FINALIZED RESPONSE TO QUESTIONS ON TRIAL BURN PLAN

COMPOSITE OF TECHNICAL COMMENTS RECEIVED DURING COMMENT PERIOD

CDH COMMENTS OF JANUARY 22, 1987 ON THE
TRIAL BURN PLAN SUBMITTAL OF OCTOBER 22, 1986

FIGURE I
ATTRITION RATE OF BED MATERIAL
FOR THE FLUIDIZED BED INCINERATOR

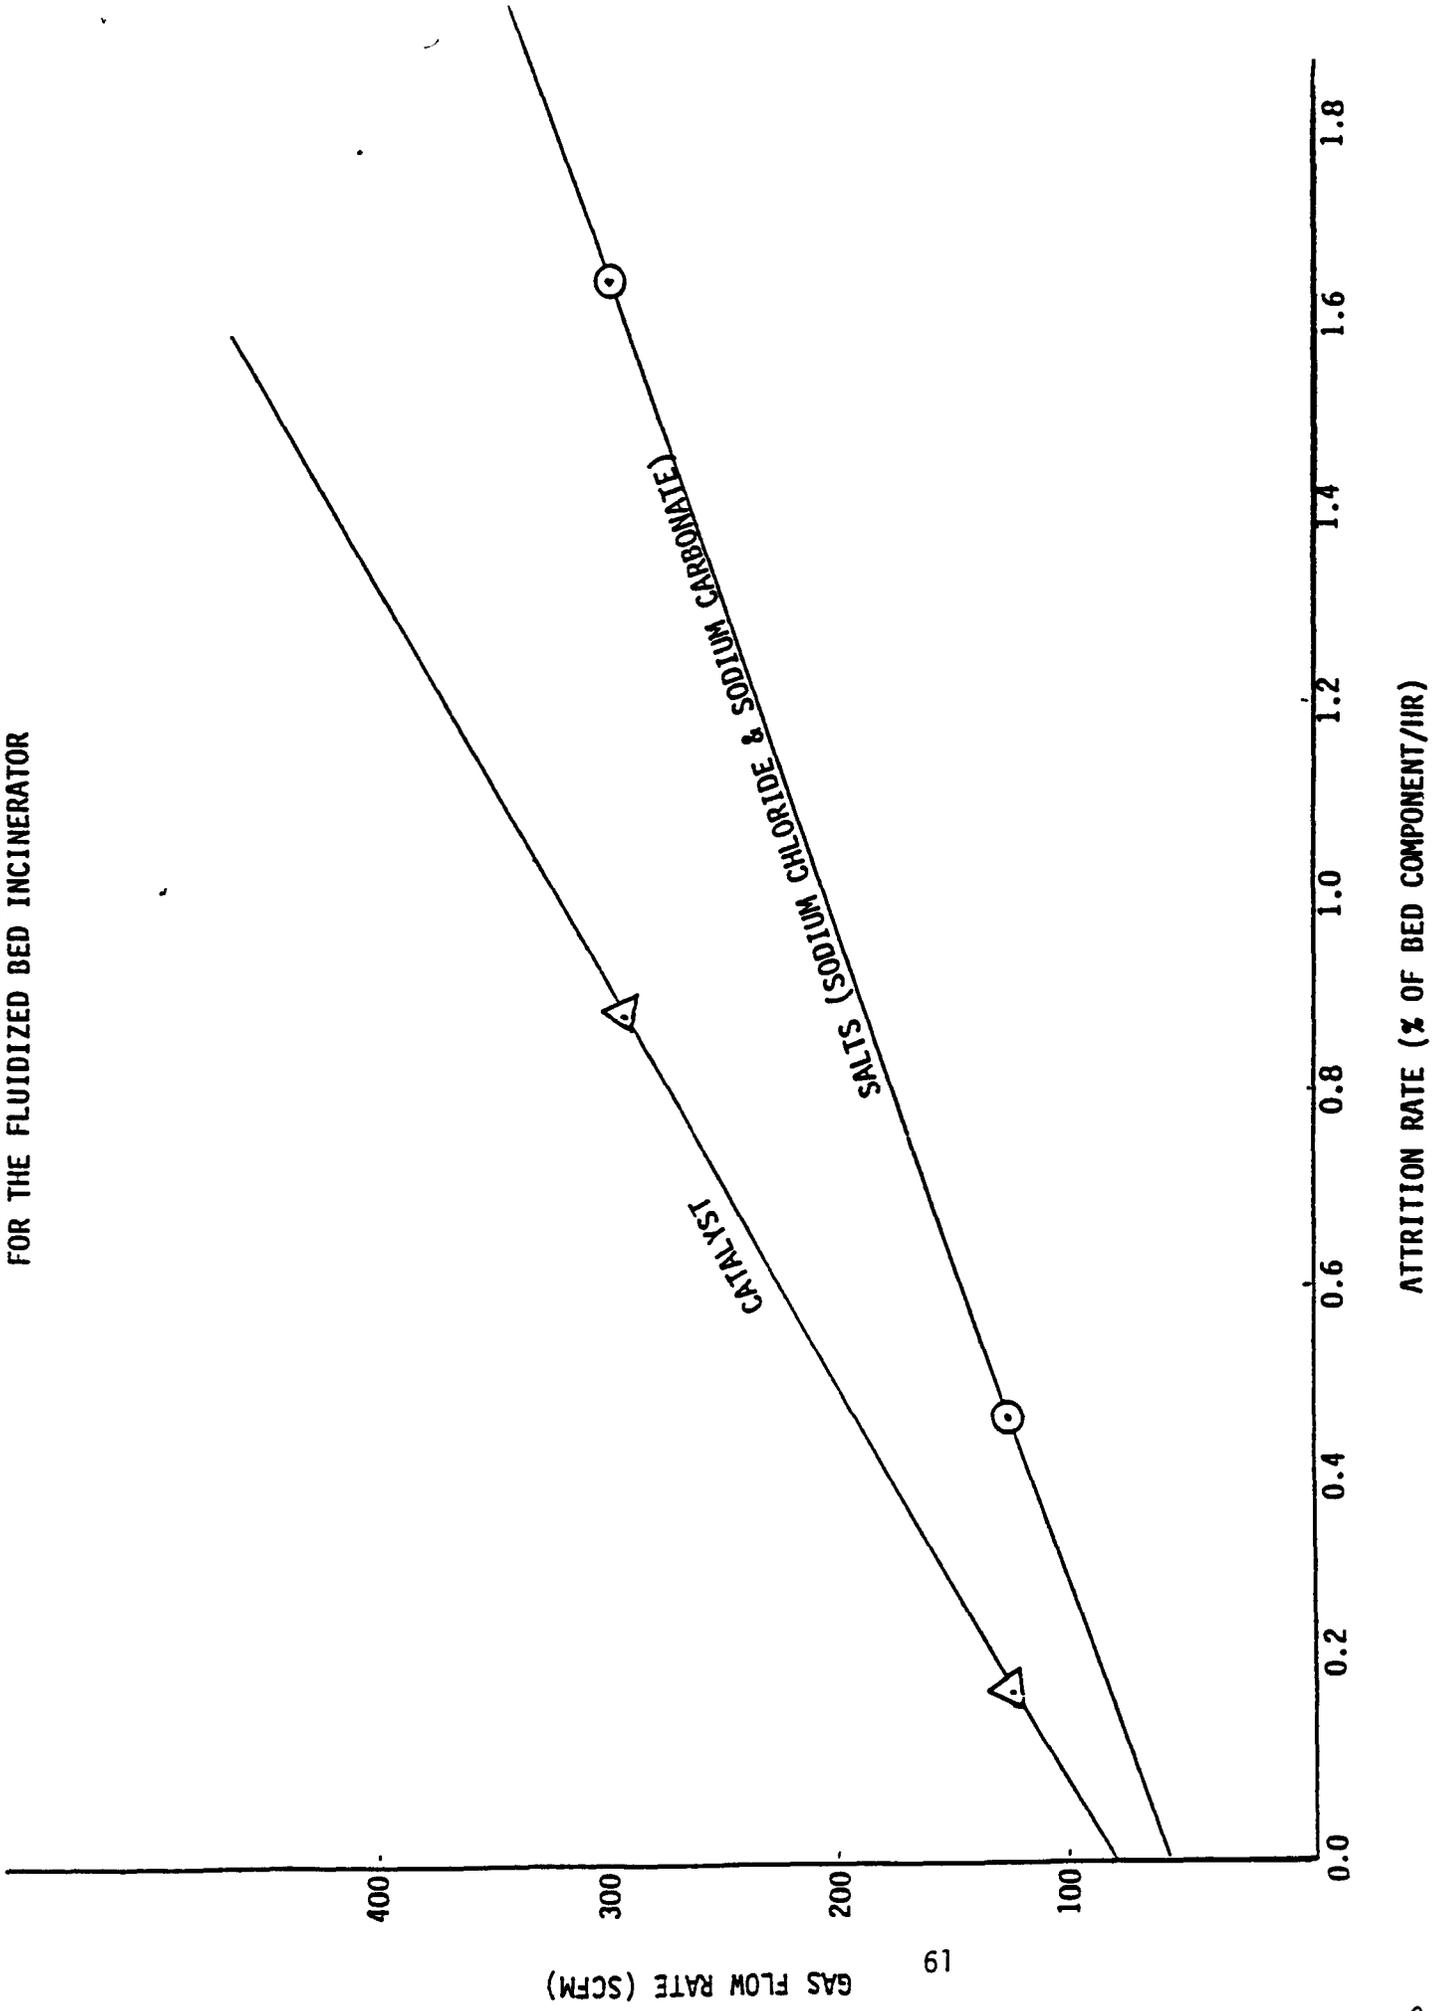
(Sodium Carbonate) Sodium carbonate is consumed through the formation of halogen, sulfur, and phosphorus salts and by loss through the outgas from the first reactor. How, and at what rate must the sodium carbonate be replaced? How is the replacement rate monitored? How are the salts that are formed separated from the bed solution? How are they carried off by the offgas while the bed mixture remains behind? Does buildup of these salts occur in the bed mixture?

As discussed in Item 3 above (response to comment number 3 from the CDH Comments of January 22, 1987), the rate of catalyst loss from the bed is determined by the gas flow rate and attrition rate as defined in Figure I. Adjustment of the catalyst concentration would then be made by adding catalyst to the primary bed on a daily basis by pneumatic transfer from the bed material feed box. The chromic oxide catalyst has not exhibited deactivation in this application for the following reasons:

The trial burn will be started with a bed containing 80% sodium carbonate and 20% catalyst. On a daily basis the catalyst and carbonate additions will be made based on data provided in Figure I. The catalyst addition to the afterburner will be made based on the attrition rate data.
